DOCKET ITEM #14
Text Amendment #2019-0004
Rezoning #2019-0005
CDD Concept Plan #2019-0002
Greenhill South CDD – 600 South Pickett Street

Purpose of Application

**Text Amendment #2019-0004, Rezoning
#2019-0005, Coordinated Development
District Conceptual Design Plan #2019-0002
600 South Pickett Street**

Figure 1: Preliminary CDD Concept Plan

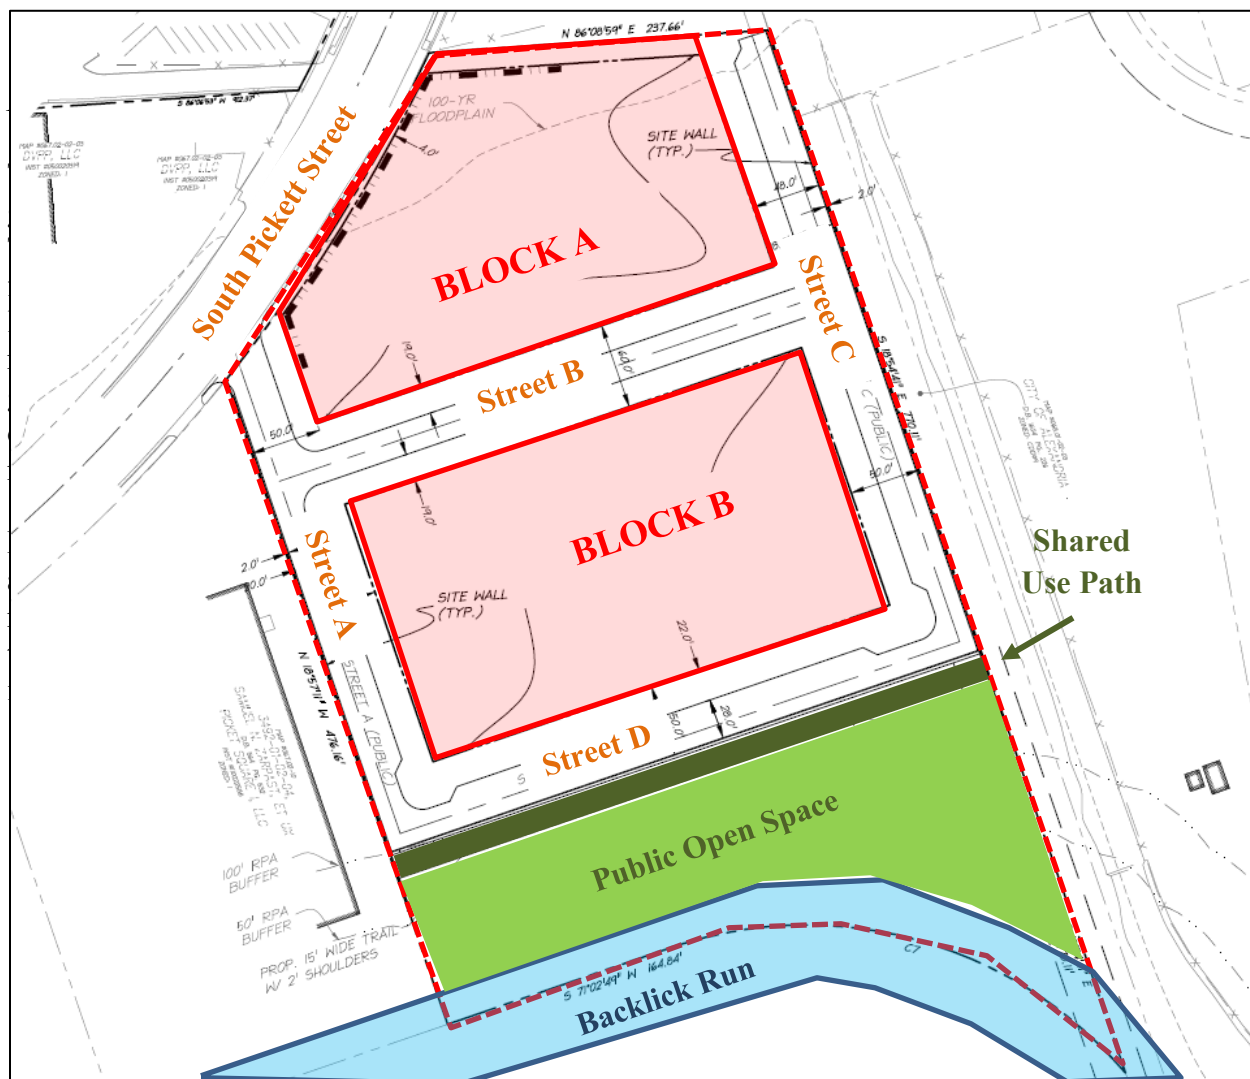
- 14. Depict on the final CDD Concept Plan submission that retail/commercial uses extend the entire length of the western side of Block A, consistent with the Eisenhower West Small Area Plan. (P&Z)

- 15. Depict on the final CDD Concept Plan submission the shared-use bridge with a minimum clear width of 10 feet connecting from the east end of the trail shown on the plans at the eastern property line to the closest feasible landing point adjacent to the western property line of Armistead Boothe Park. (T&ES)(P&Z)

17. On the final CDD Concept Plan, revise the size of the existing RCP pipe from the 48-inch size listed on the preliminary CDD Concept Plan to the 42-inch size listed in City records. Sanitary sewer outfall analyses in future DSUP submissions should account for this revision. (T&ES)

18. Add a note on the final CDD Concept Plan indicating that curb lines are for illustrative purposes only. (P&Z)
19. The grade differences between the CDD Concept Plan area and abutting properties depicted the preliminary CDD Concept Plan shall be minimized to the greatest extent feasible to the satisfaction of the Directors of Planning & Zoning and Transportation & Environmental Services. Such adjustments of grade shall be depicted on the final CDD Concept Plan if they requested prior to or concurrent with said submission. (P&Z)(T&ES)

20. Add to the final CDD Concept Plan submission a new plan sheet that depicts how the future new buildings, streets, and other improvements at the site will be phased. The applicant may request administrative approval of revised project phasing, without the need for public hearings, subsequent to approval of the final CDD Concept Plan to the satisfaction of the Directors of Planning & Zoning and Transportation & Environmental Services. If revised project phasing is requested subsequent to the final CDD Concept Plan approval, the applicant shall provide a revised phasing plan illustration upon request by the Directors. (P&Z)
